**MEMORANDUM**

REVIEW TYPE: **Site Plan Review**
 CASE #: **81996011D (formerly 8-96011D)**
 PROJECT NAME: Kings Crossing
 APPLYING FOR: Approval of 102 Multi-family Moderately Priced Dwelling Units (MPDUs) on 5.20 acres
 REVIEW BASIS: Div. 59-D-3 of Montgomery County Zoning Ordinance
 ZONE: PD-2
 LOCATION: On Kings Crossing Boulevard, directly north of the intersection with Clear Smoke Road
 MASTER PLAN: Germantown Master Plan
 APPLICANT: J. Kirby Development, LLC
 FILING DATE: November 10, 2004
 HEARING DATE: January 5, 2006

Area designated as
"Additional" or
"Optional" Parking
Spaces

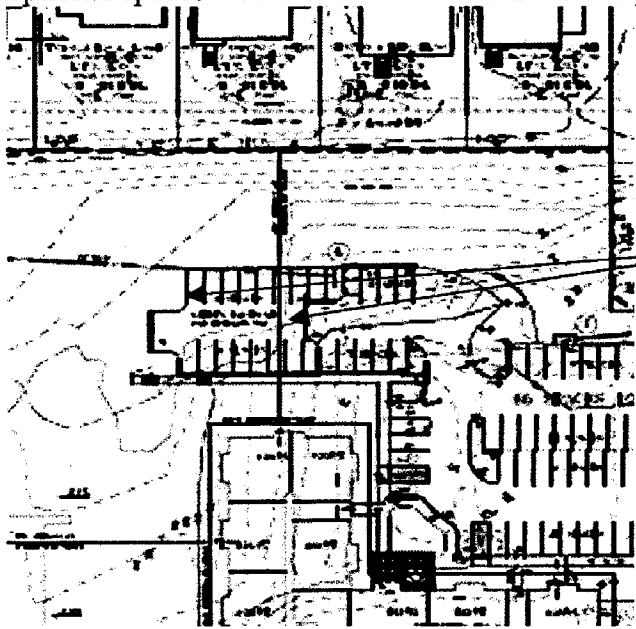
The Applicant is requesting a waiver to the 20.4 percent cap in order to accommodate 17 additional parking spaces and associated sidewalks and drive aisle behind Building No. 2. The waiver would increase the cap for this site by two-tenths of a percent and one-tenth overall. The Applicant has shown the additional 17 spaces as optional in order to illustrate the construction of the spaces if the Planning Board approves the waiver. If the waiver were not approved, the optional spaces would be removed from the site plan application.

The waiver requested by the Applicant is needed to accommodate 17 additional parking spaces in the rear of Building No. 2. The additional spaces are needed to provide adequate parking for senior residents that equate to a 2:1 ratio of cars to units. The additional 3,025 square feet of impervious is only a tenth of a percent increase in the overall subdivision and two-tenths of an increase on the subject site. The Applicant believes the increase does not result in a detrimental impact to the watershed and Little Seneca Creek, and sees the parking spaces as a necessary component to the senior residents. The Applicant also believes that the marketing plan for the senior MPDUs will be more enticing if each unit is provided with two dedicated parking spaces.

The Woodcliffe community has expressed an opinion to staff and the Applicant in support of additional parking spaces for the future residents. The concern from the community is that there is a potential for owners of the building to park on the streets and in the spaces reserved for the nearby clubhouse/pool, some of which will be allocated for the future residents of Building No. 1. The community is also concerned that residents may have extended families with additional vehicles that may overburden the limited amount of parking spaces on the property. The

Staff has consistently recommended that sites within sensitive areas that limit the amount of impervious should maintain the minimum amount of paved surface on the property. Staff is not in support of additional impervious on this site, because there is still a potential for homeowners to increase the width of their driveways once the subdivision is fully developed. If homeowners choose to increase the width of their driveway it could add an additional 100 square feet of impervious coverage to each lot, creating a greater environmental impact to the watershed and Little Seneca Creek. Staff also believes that the parking proposed for the two buildings is adequate for the future residents. The parking requirement for a market-rate two-bedroom unit is 1.5 spaces per unit, resulting in only 153 spaces. A 50 percent reduction is permitted for MPDUs, which would result in 77 fewer spaces on the site. Staff is not recommending that the applicant take advantage of a reduction in the number of parking spaces; however, it should be pointed out that with or without the reduction, the site is over parked. Increasing the number of spaces and impervious coverage would only exacerbate the impact to the environmentally sensitive areas within the watershed.

Staff is opposed to the additional parking spaces proposed with this application and the increased amount of impervious on the site.

3. Site Design
 - a. The Applicant shall remove the 17 parking spaces, drive aisle and sidewalks (shown as optional) between Building No. 2 and the adjacent one-family homes to the north to comply with the impervious restrictions on the site.
